January 6, 2026
File No. 25-466

**Subject: Letter of Concurrence & Additional Geotechnical Recommendations
Proposed SFR
5818 West Mercer Way, Mercer Island, WA**

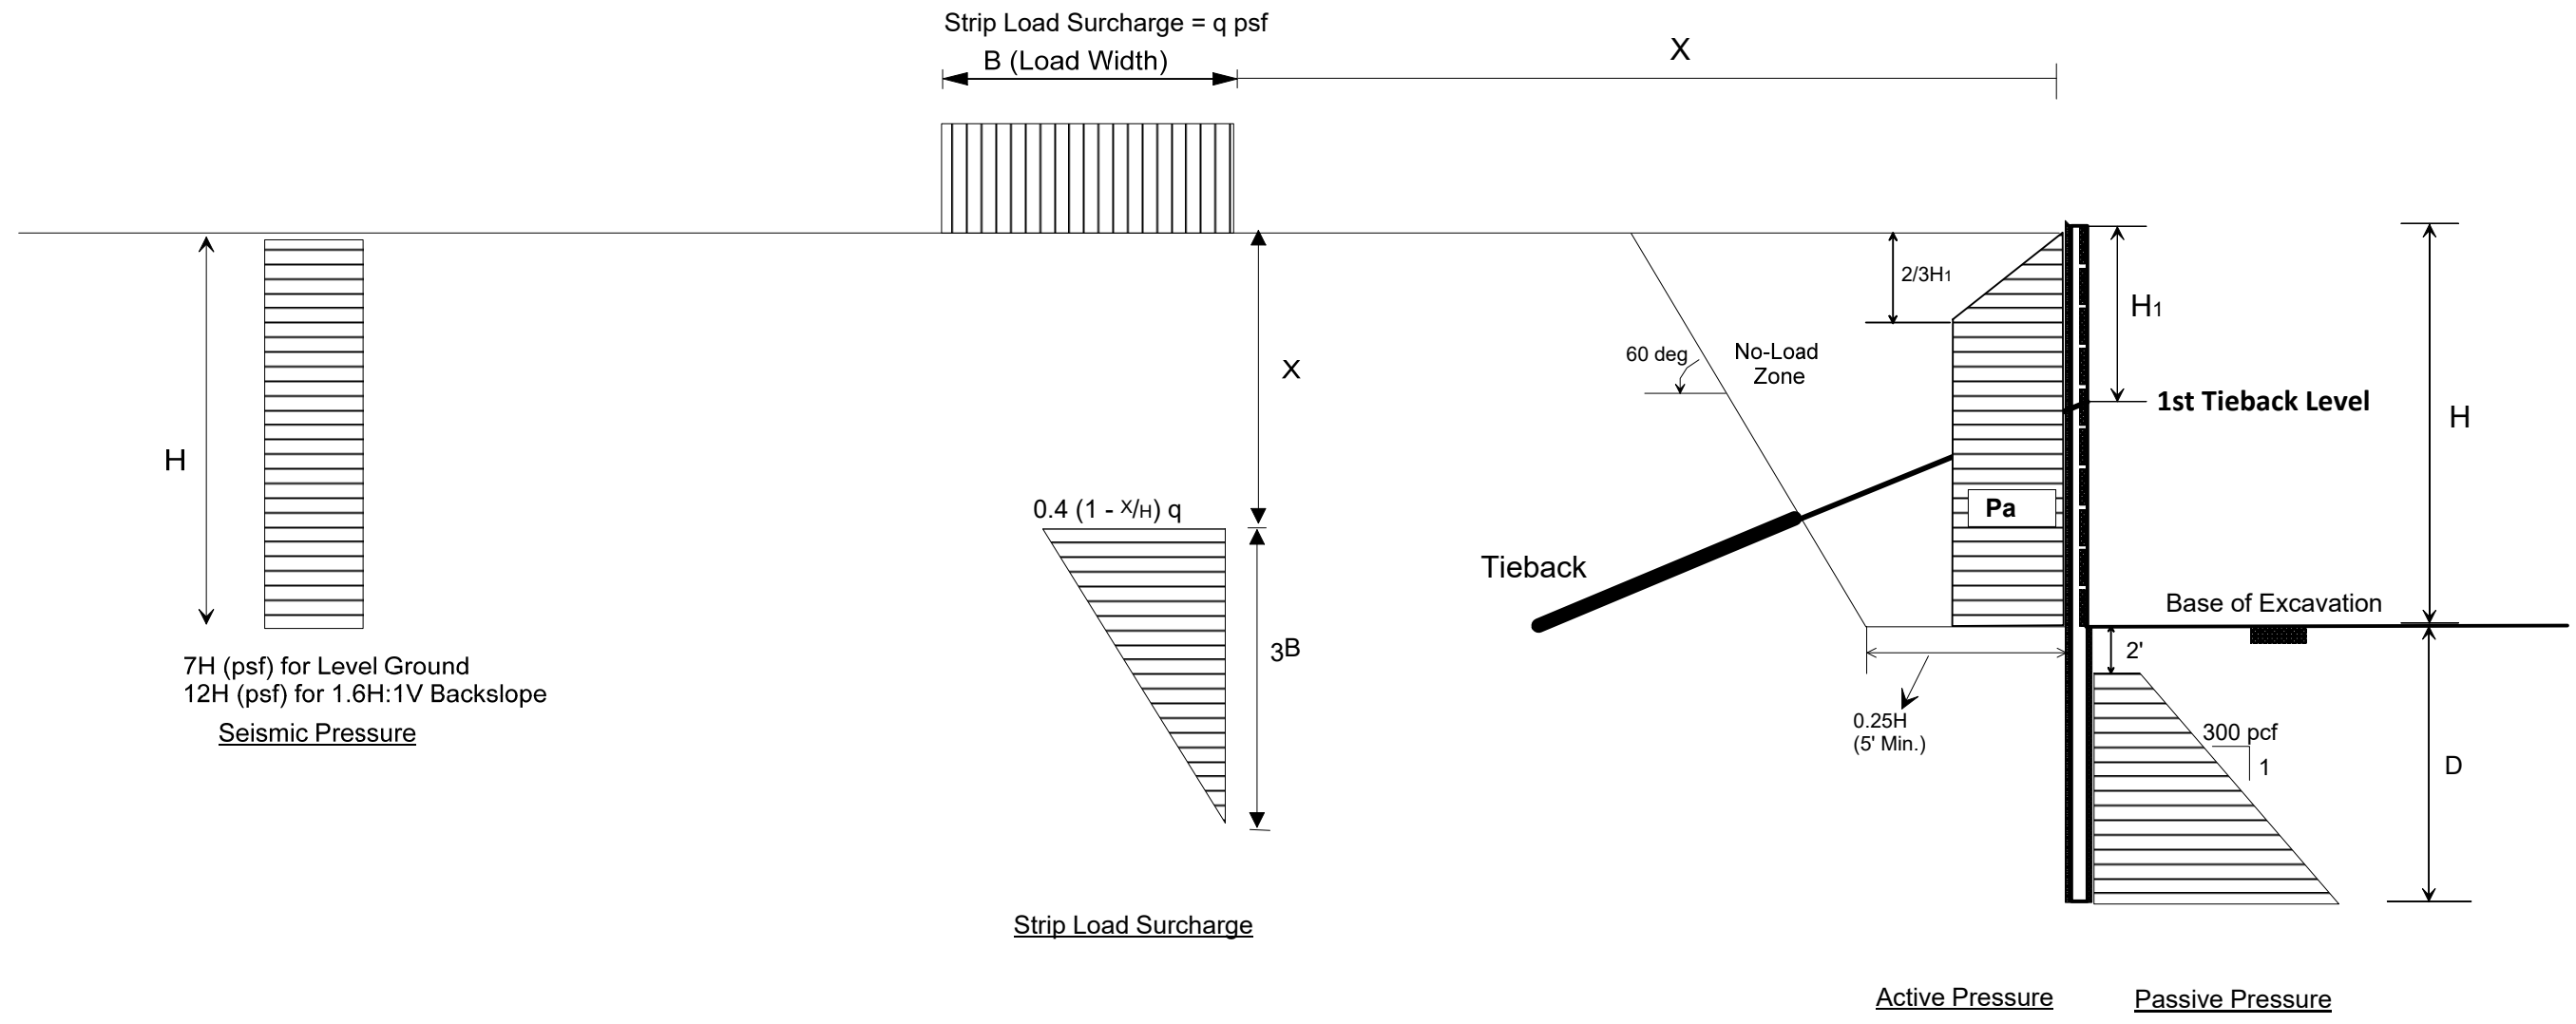
Based on the current plans, we understand that temporary and permanent soldier pile walls with tiebacks will be needed to support temporary excavations and permanent cuts along the east and south sides of the proposed building. For cantilevered soldier pile walls, we recommend that the earth pressures depicted on Figure 1 be used for design. For soldier pile walls with one or more levels of tiebacks, we recommend that the earth pressures depicted on Figure 2 be used for design. The lateral earth pressures shown on Figures 1 and 2 should be increased for any surcharge loads resulting from construction equipment, storage of construction materials, or excavated soil if they are located within the height dimension of the wall.

Above the bottom of excavation, the recommended active earth and surcharge pressures should be applied over the full width of pile spacing. Below the bottom of excavation, the active and surcharge pressures should be applied over one pile spacing, and the passive resistance should be applied over 2.5 times the pile diameter.

Temporary Shoring Walls:
 $P_a = 35$ pcf (Level Background)

Permanent Shoring Walls:
 $P_a = 50$ pcf (Level Background)

Earth Pressure Factor for Backslope	
Backslope, X:1	Earth Pressure Factor (A)
Level	1
3H:1V	1.2
2H:1V	1.4
1.6H:1V	1.55

- Notes:
1. Minimum embedment should be at least 8 feet below bottom of excavation.
 2. A factor of safety of 1.5 has been applied to the recommended passive pressure values. No factor of safety has been applied to the recommended active earth pressure values.
 3. Active pressures should be applied over the full width of the pile spacing above the base of the excavation, and over one pile diameter below the base of the excavation.
 4. Surcharge pressures should be applied over the entire length of the loaded area.
 5. Passive pressure should be applied to 2.5 times the diameter of the soldier piles, or pile center-to-center spacing, whichever is less.
 6. For lagging design, refer to report text.
